CITY OF ALBUQUERQUE

June 13, 2022

RE: 543 Old Coors Dr. SW
Grading and Drainage Plans
Engineer's Stamp Date: 06/11/22
Hydrology File: K11D027

SHEET NO. C-2

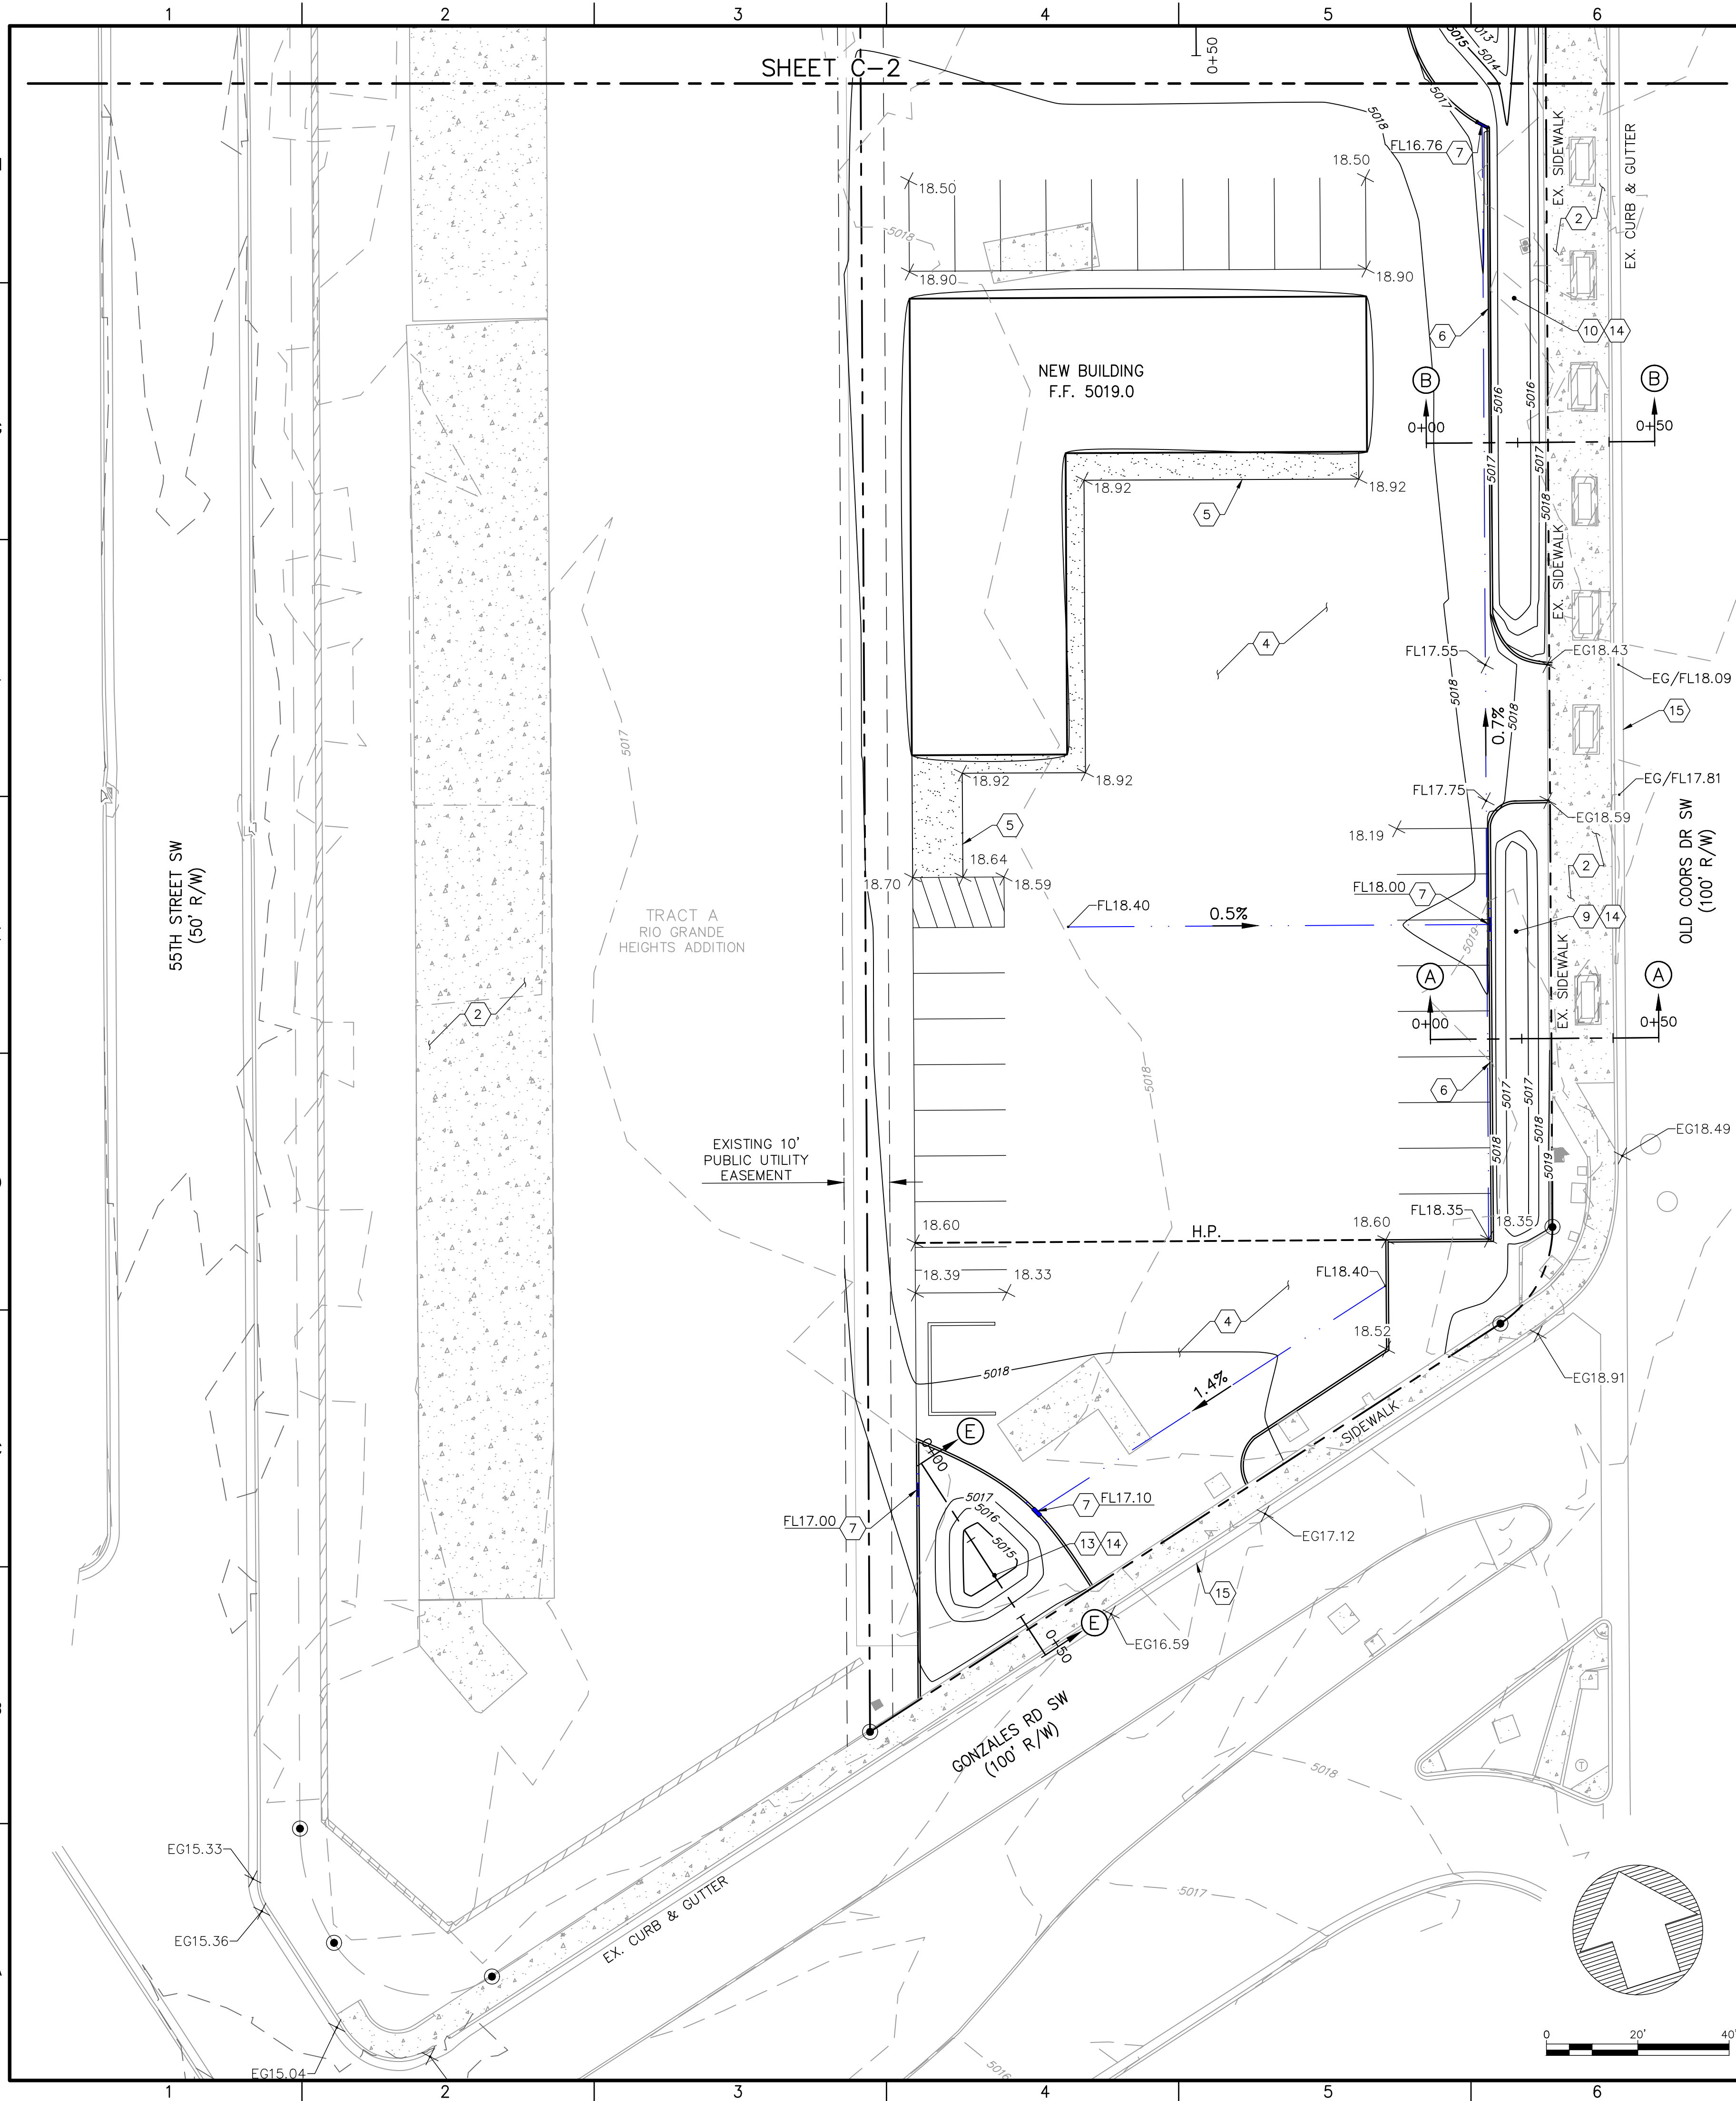
7. Please provide better detail on how this pond is being discharged into the sidewalk culvert. Also, please draw the sidewalk culvert correctly. The steel plates need to extend one foot into the property. The City does not allow more than three -2 feet culverts together. Again, please refer to the standard detail.

8. Please provide a detail for the wall opening. Also, please note that wall appears not to be stable and may need to be replaced.

PROJECT NO: 22035
DESIGNED BY: RJF
DRAWN BY: JB
CHECKED BY: RJF
DATE: JUNE 2022
SHEET TITLE
GRADING PLAN
DETAIL
SHEET NO: C-3

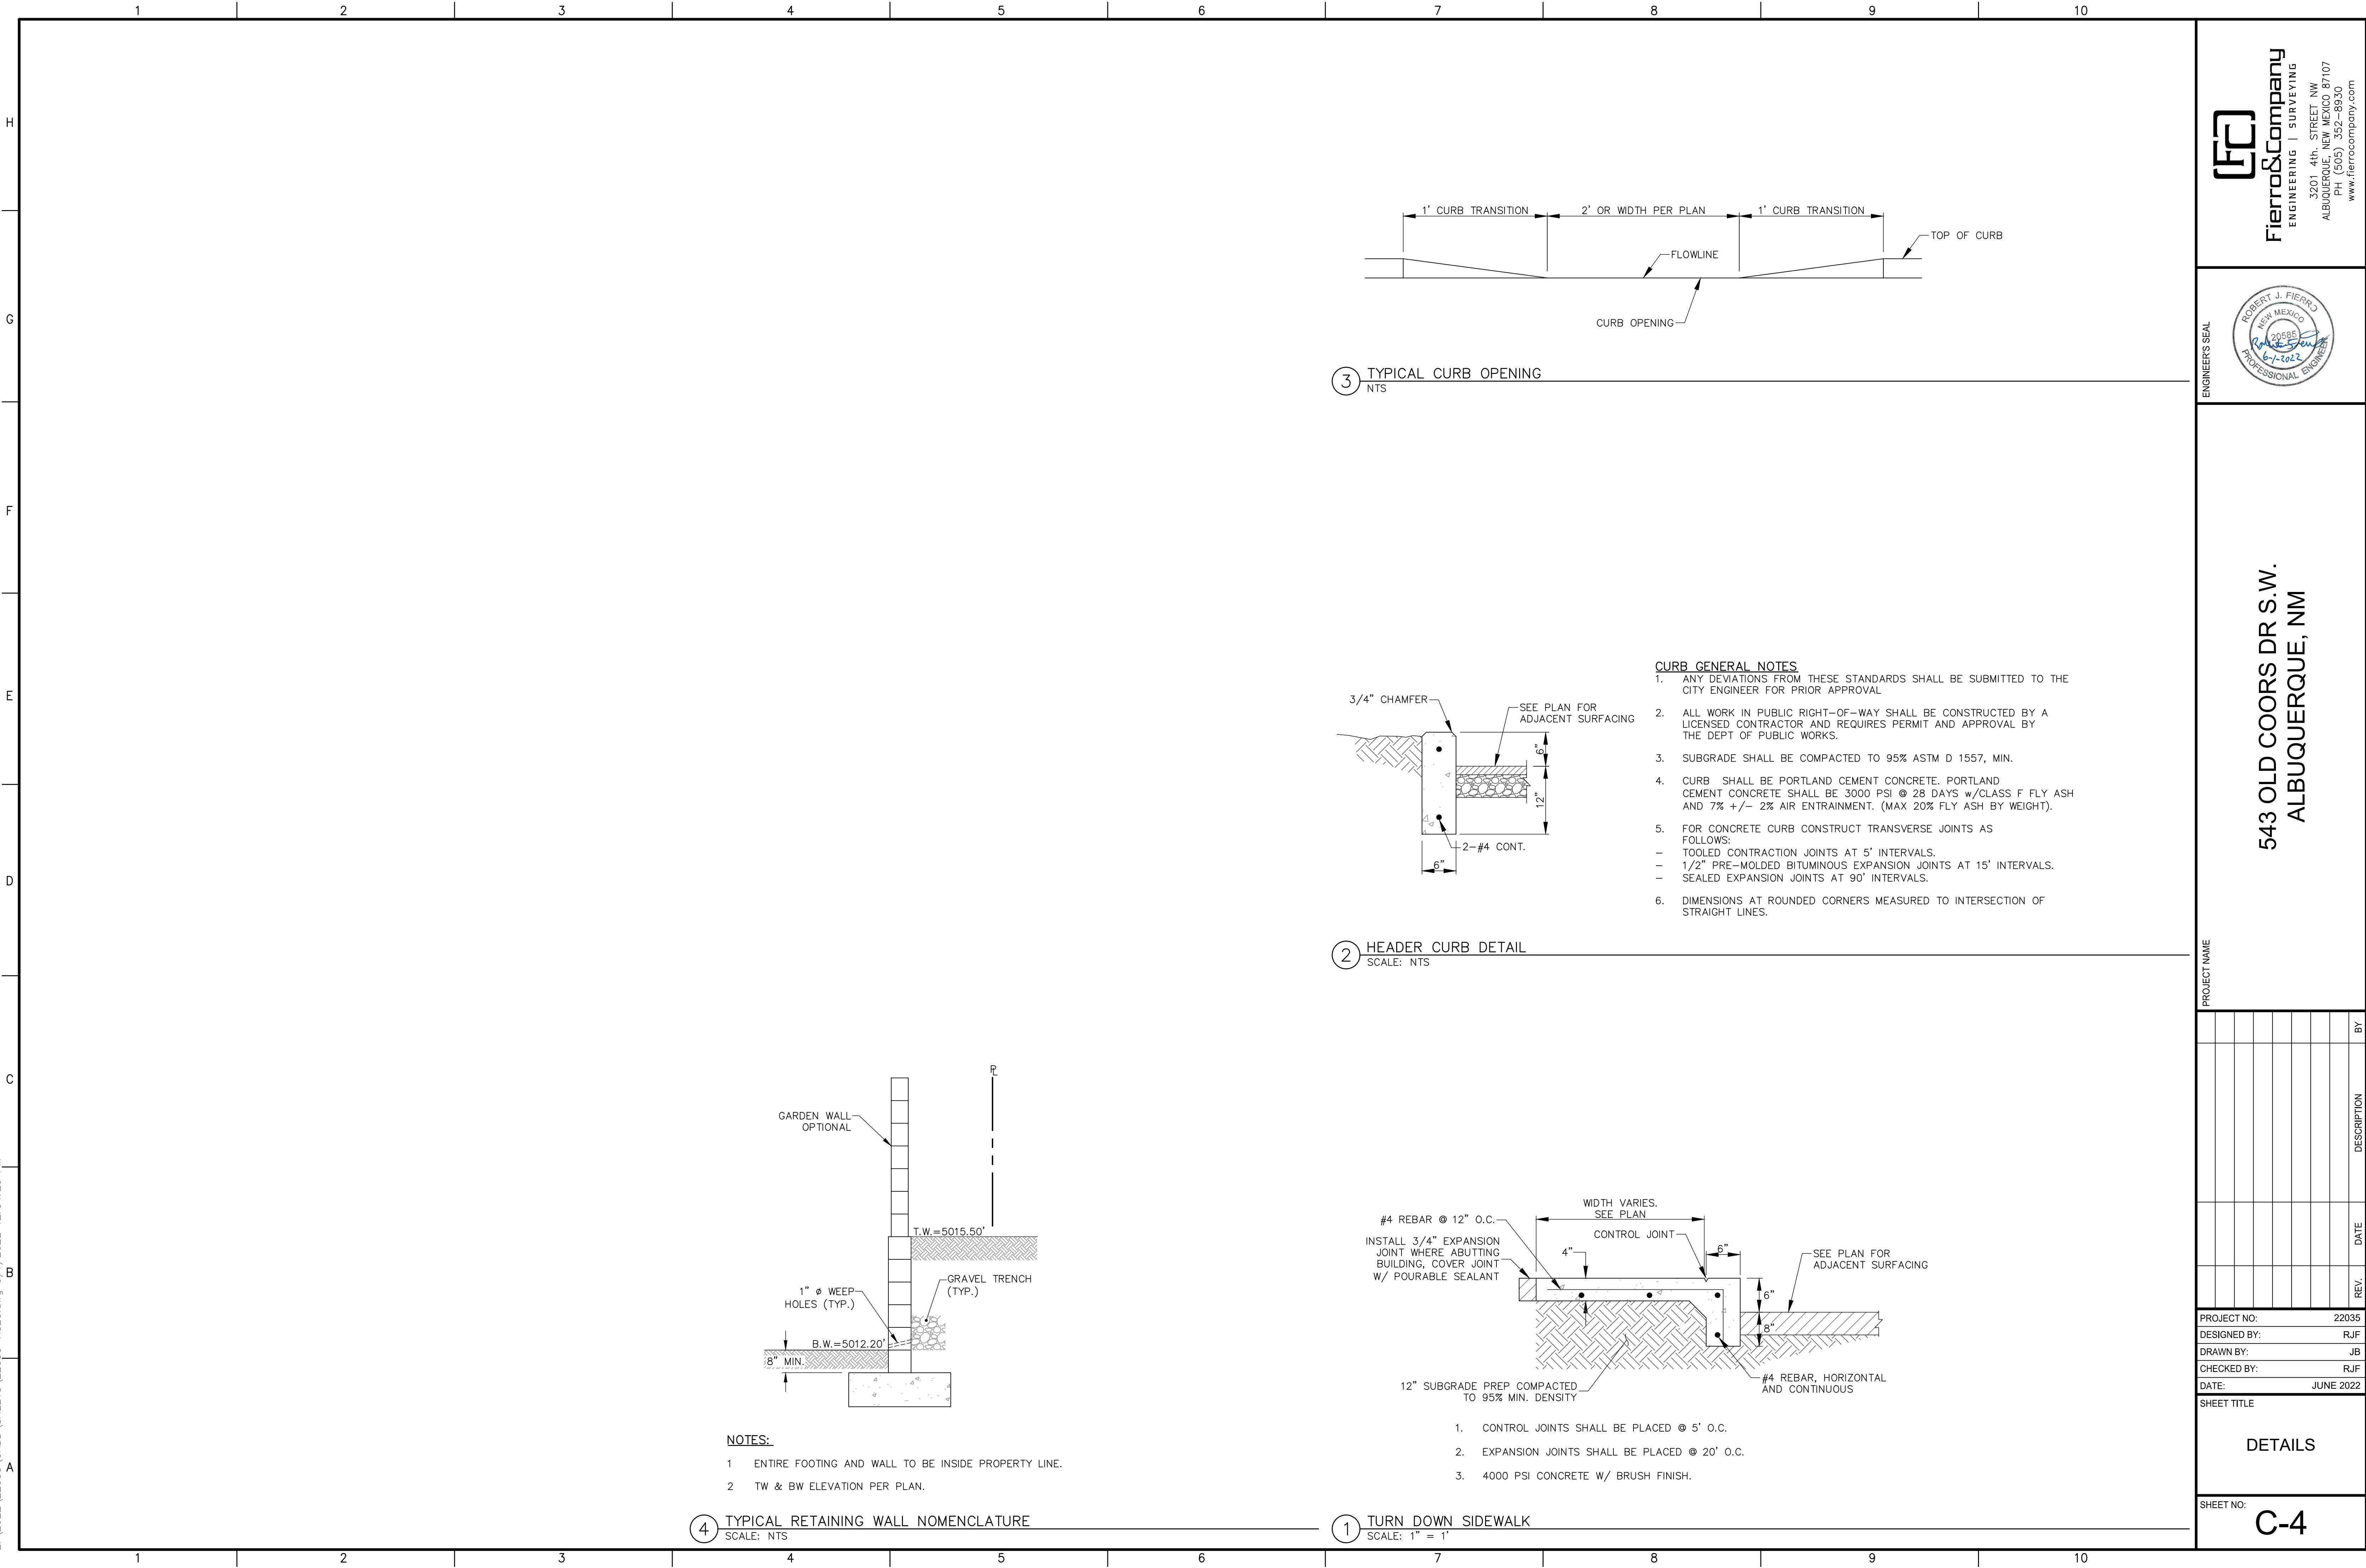
13. Why is this portion of the parking over the property line and into Tract A? Also, where is the edge of the asphalt from the parking to the header wall?

14. How is this detention /stormwater quality pond being discharged? There needs to be some sort of spillway / outfall for it. Please revised.

15. How is this detention /stormwater quality pond being discharged? There needs to be some sort of spillway / outfall for it. Please revised.

16. Again, I am not quite sure where the edge of asphalt is on this project. Also, what is this piece of concrete for? Is it proposed or existing? All the lines are the same line weights so it is hard to tell what is being proposed and what is existing.

SHEET NO: C-4

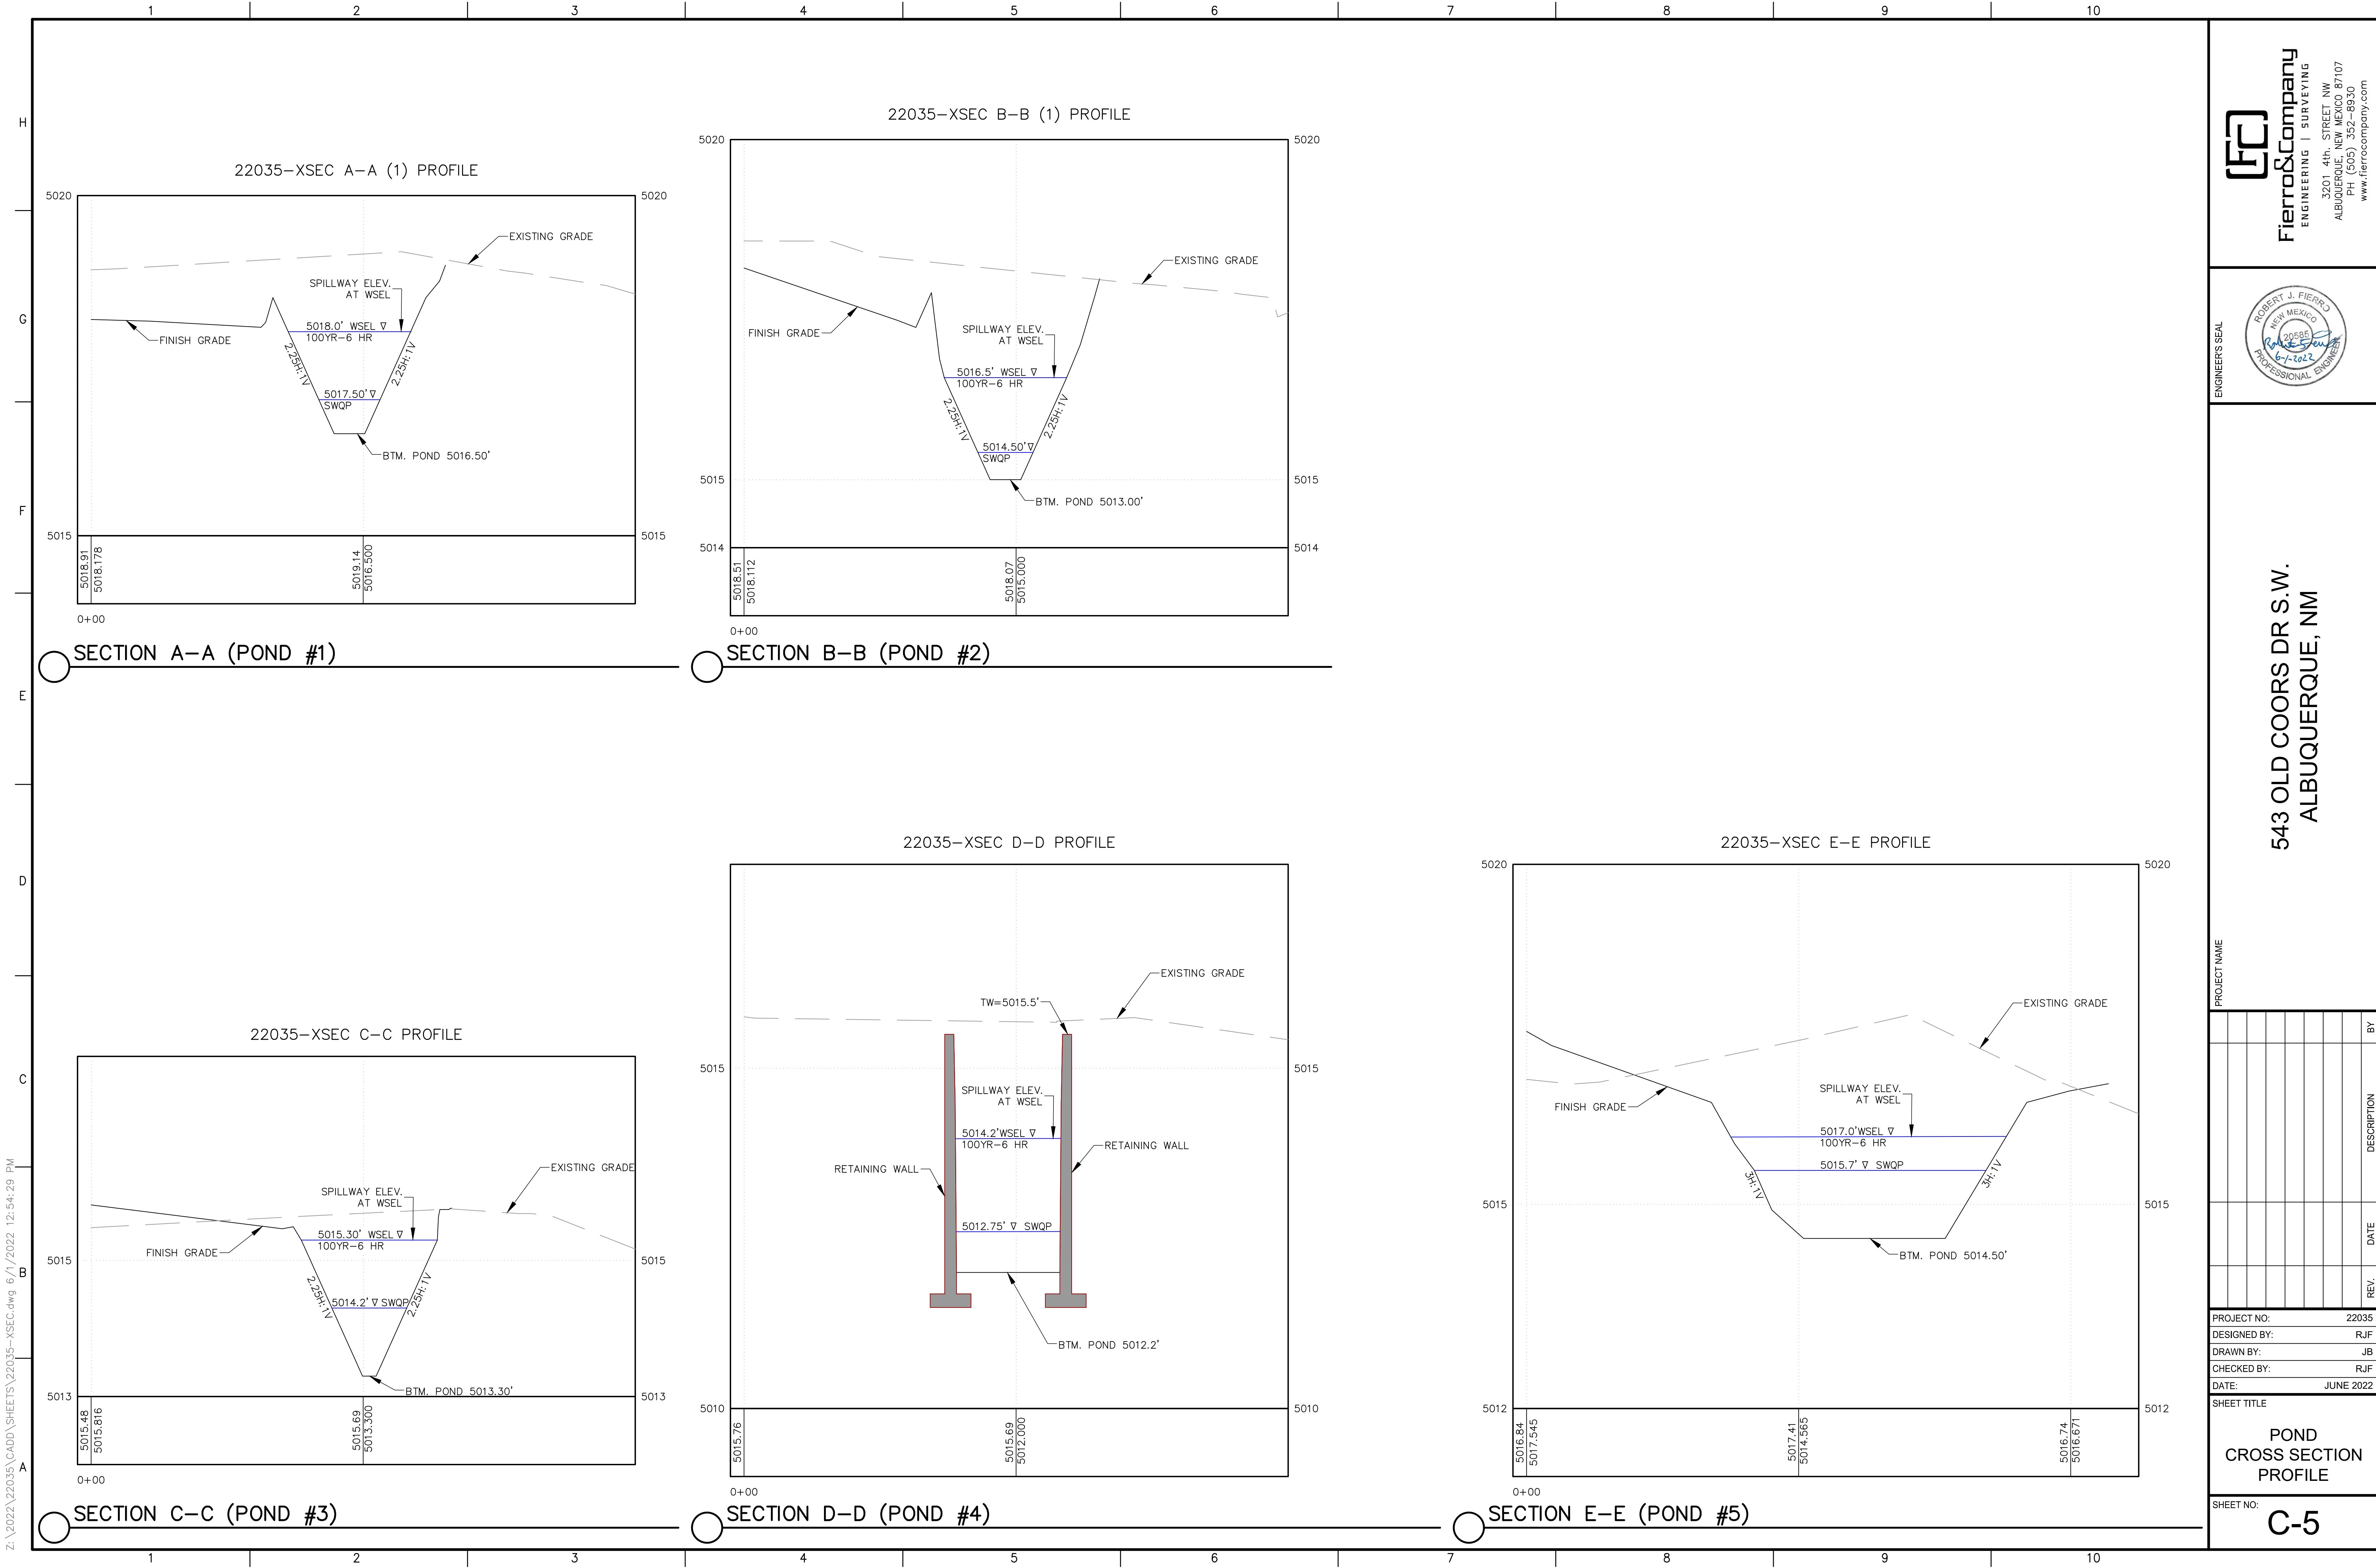
17. Either use your header curb detail or just call out the City Standard Detail. It appears that you have call out the City's detail so the header curb needs to be removed.

18. Please add the distance from the property line to the garden wall.
